MHTN
ARCHITECTS

Addendum No. 02

Project Name: **SJSD Albert R. Lyman Middle School**

Addendum No. 02 to the Construction Contract for the above-referenced project:

SHEET NAME
ENLARGED FOOTING AND FOUNDATION PLANS

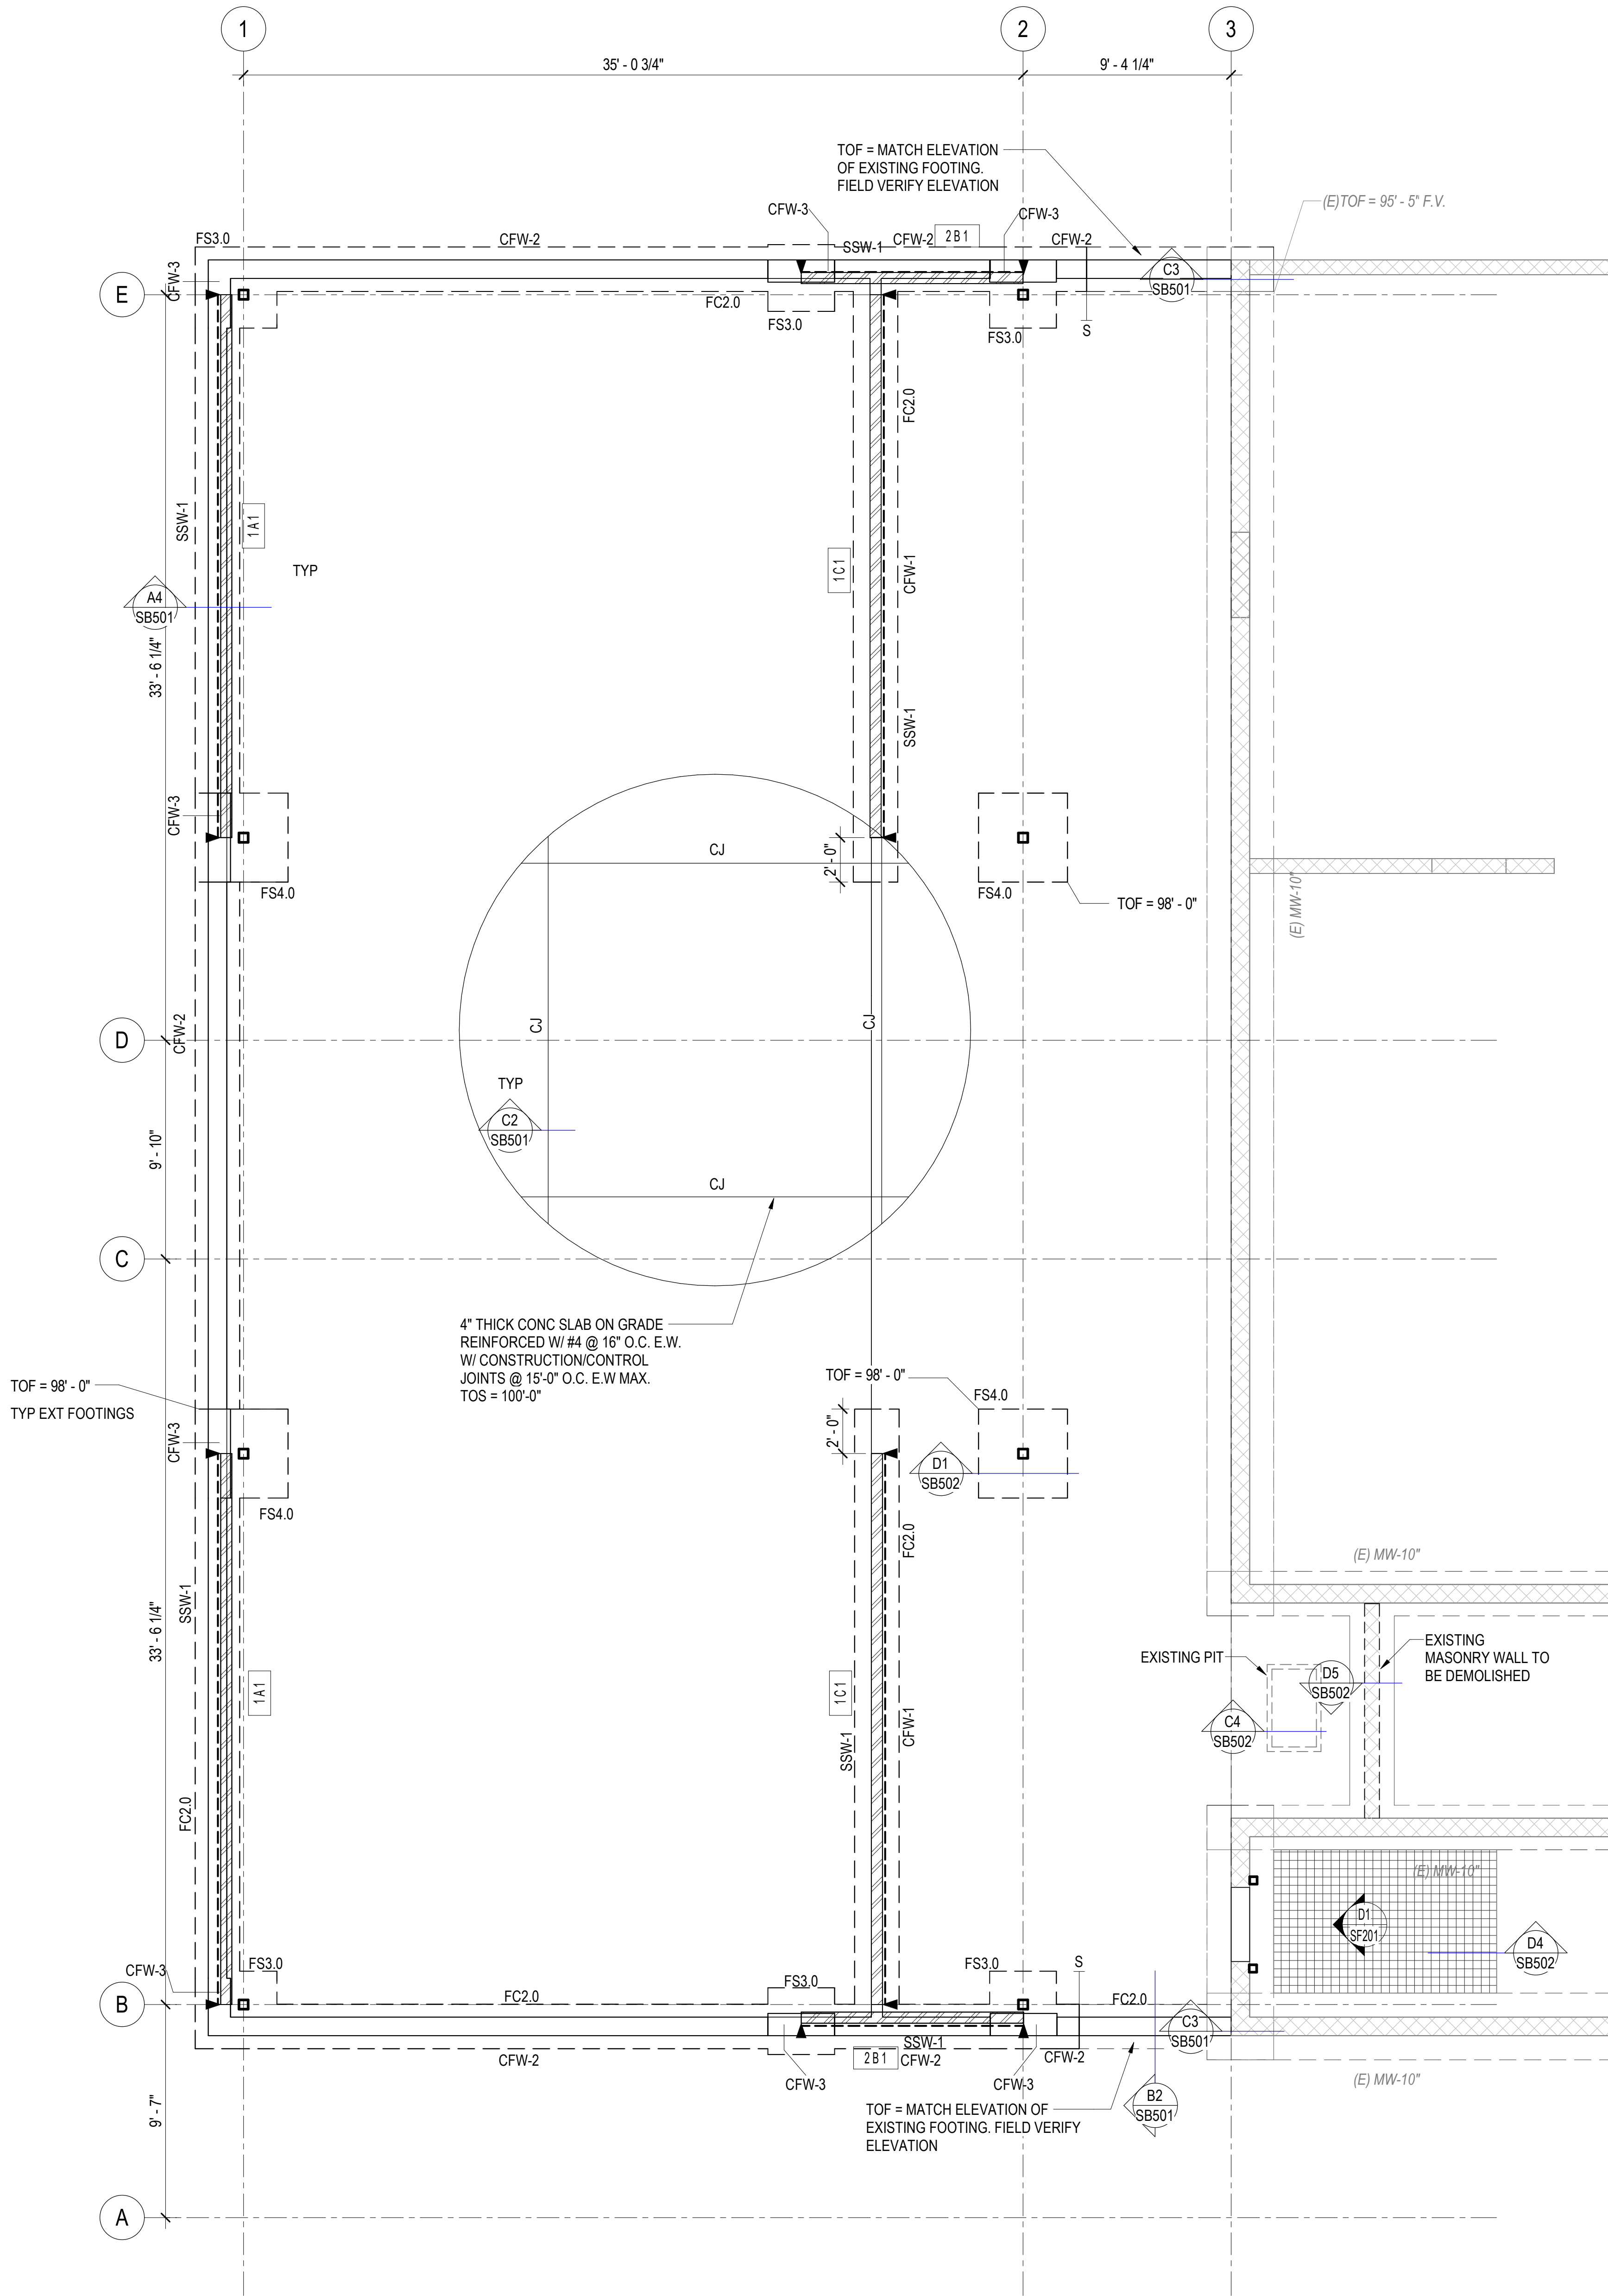
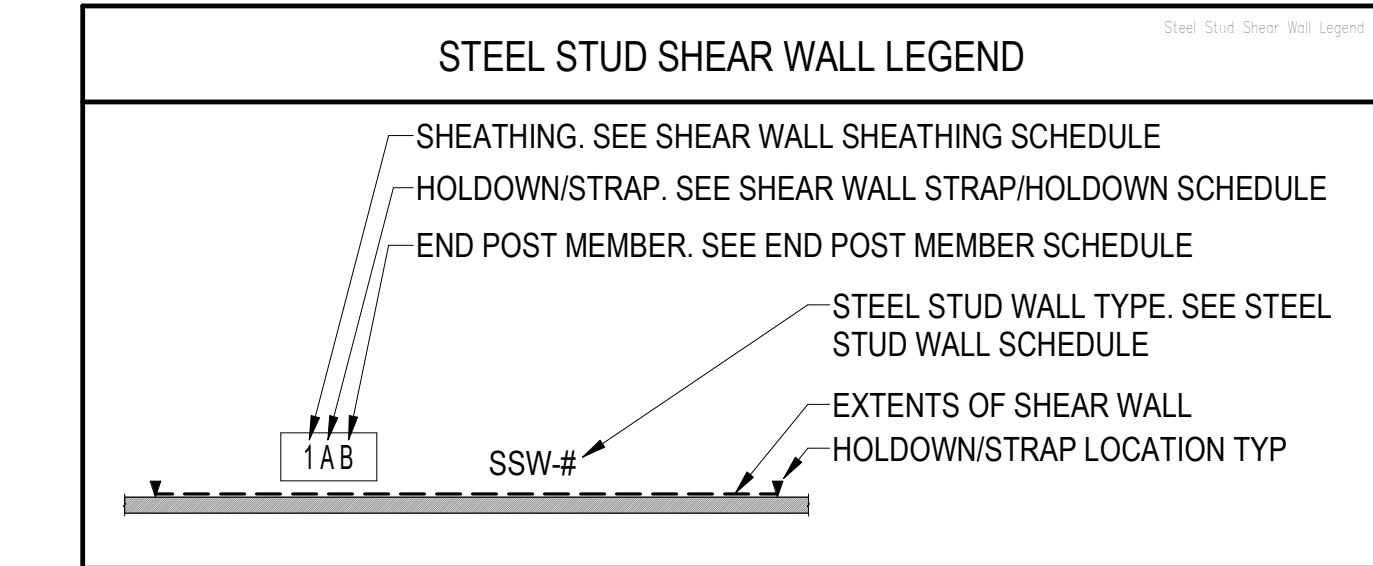
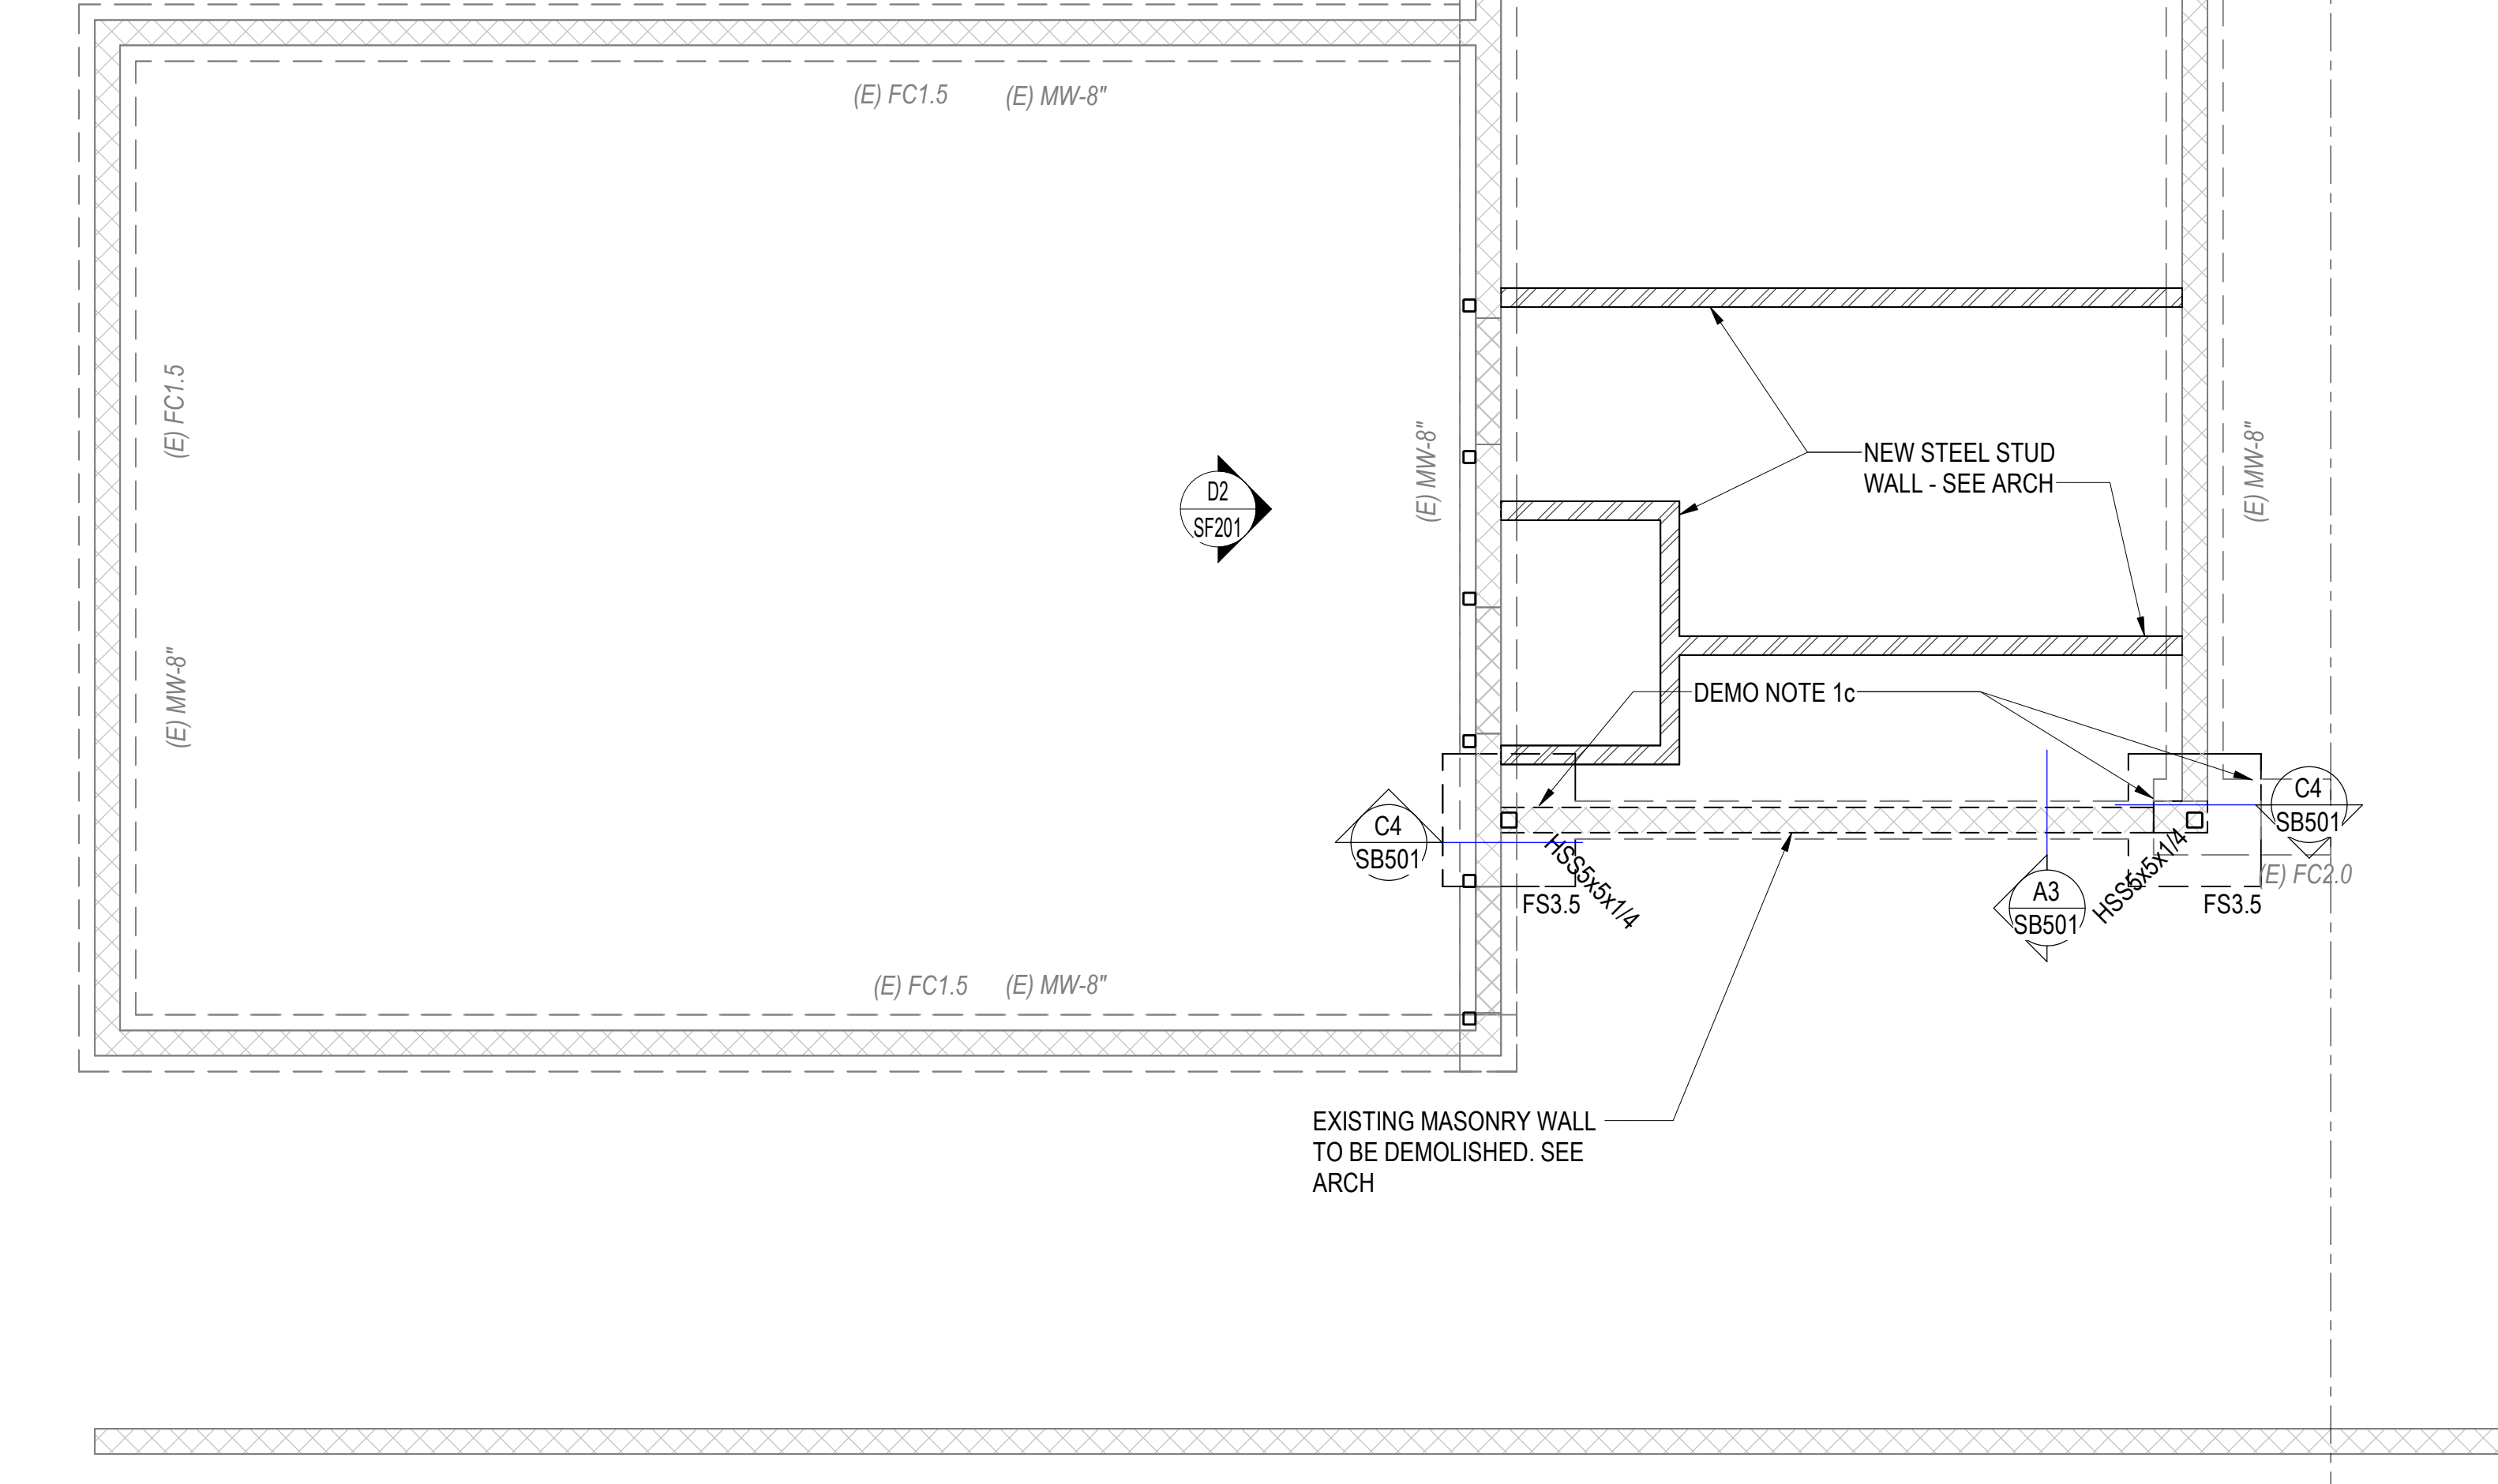
S2.1 Sheet SB102 – Enlarged Footing and Foundation Plans:
